Determination 2021/012

Regarding alterations to install insulation in a skillion roof at 96 Lochiel Branxholme Road, Lochiel, Winton

Figure 4: Typical section

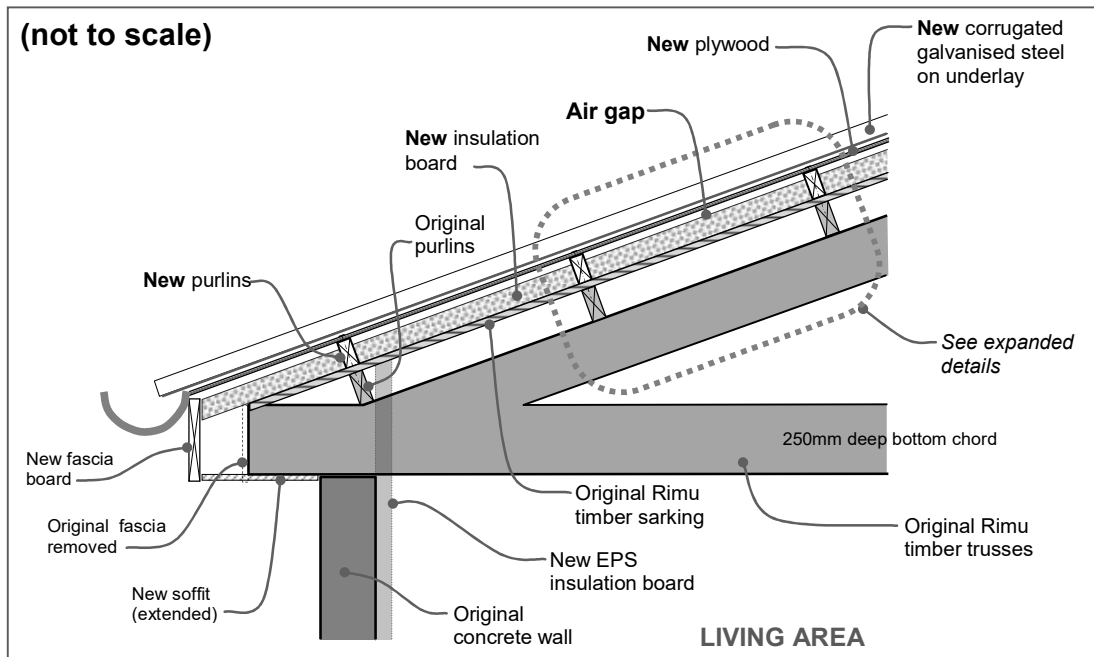
2.3.2 Figure 4 shows the general construction of the new skillion roof above the original timber sarking, with the original rimu timber trusses and sarking left exposed as shown in Figure 1. Expanded details are provided in Figures 5A and 5B.

- The 2011 skillion roof design included plywood sheet sarking to support the roof underlay with a 25mm gap above the rigid insulation board. The insulation board was cut to fit between purlins and sat directly on top of the original permeable ceiling linings – as shown in Figures 3 and 4.

- Photographs in the building surveyors report of the timber ceilings show water marks resulting from moisture migrating through the timber lining from the enclosed cavity above, with marks pronounced at junctions of linings with the exposed purlins, which align with the new purlins above as shown in Figures 4 and 5.

Figure 5A & 5B: Expanded details of consented roof

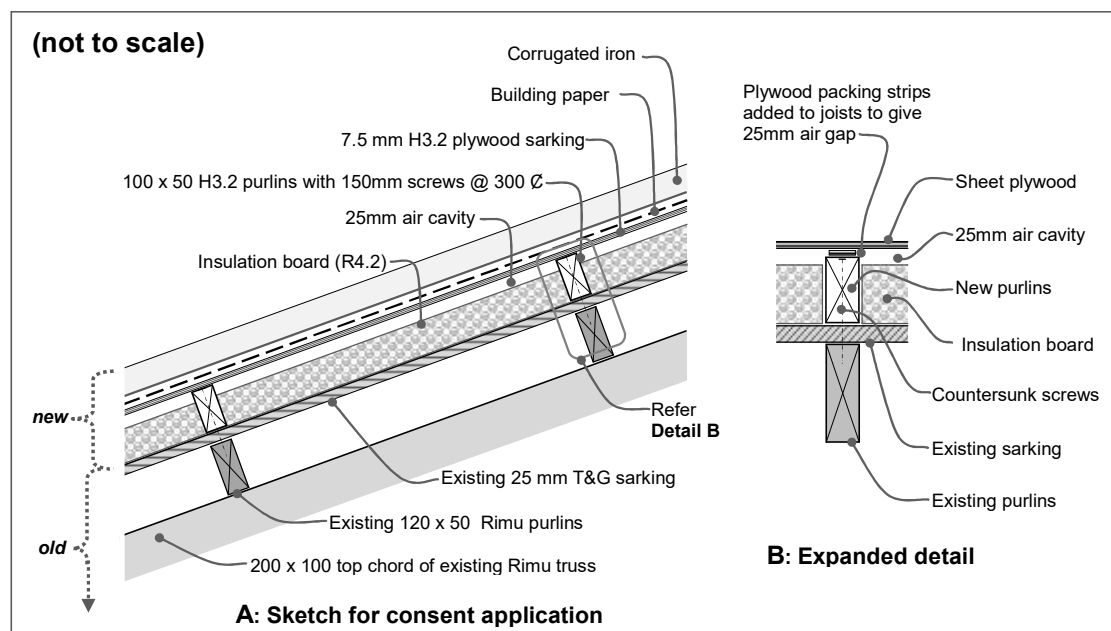
2.4.1 Figure 5A provides an expanded section of the builder’s hand-drawn sketch submitted in the application for a building consent, and Figure 5B shows the addition of packing strips to provide the 25mm air gap requested by the authority.

- However, the subject roof has continuous plywood sarking supporting the roof underlay, which has significantly reduced natural air leakage.
 - The plywood sheet enclosing the cavity (see Figure 5A) does not accord with the intent of E3/AS1 1.1.4 b), which the specialist considers is:

Figure 6: Moisture movement through the assembly

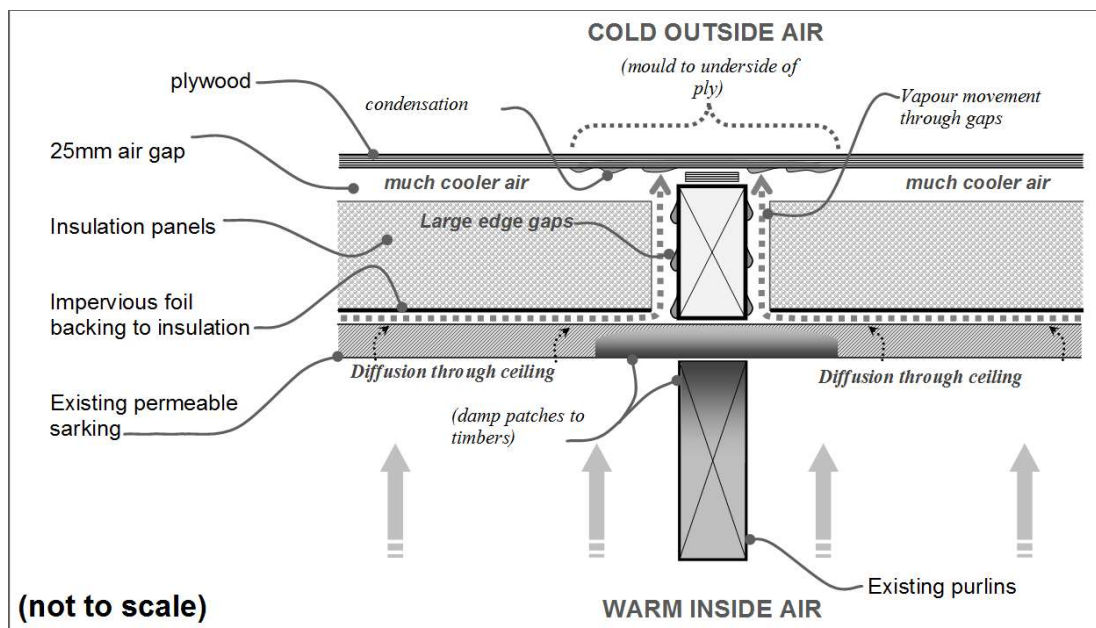
6.1.6 Moisture currently appears to be moving within and through the framing as shown in the following schematic sketch:

6.1.7 The above observations satisfy me that the skillion roof as-built does not comply with Building Code Clause E3. This is because the presence of the accumulated moisture over time would cause damage to building elements.

Figure 7: BRANZ Guidance in 2005

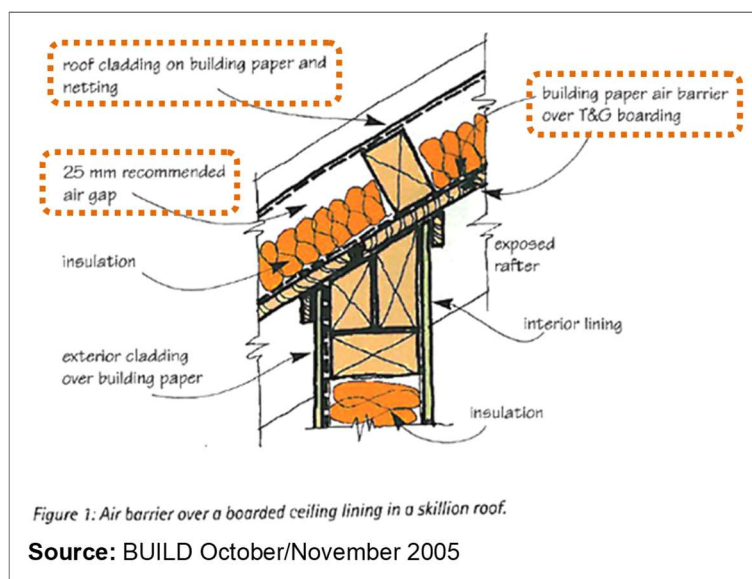
- Other BRANZ guidance current in 2011 included sketches showing ‘building paper air barrier over T&G boarding’ (see Figure 7 Appendix B,) or ‘continuous air barrier material (spec E2/AS1 Table 23) under insulation’ (see Figure 8 – Appendix 0 to B1.4).

- 6.2.16 The need for a continuous air barrier was reiterated again in BRANZ guidance published in 2005²⁰, which included an air barrier above a boarded ceiling lining in skillion roofs (see Appendix B1.2 and Figure 7), and in BRANZ guidance published in 2007²¹ (see Appendix B1.3 and Figure 8).
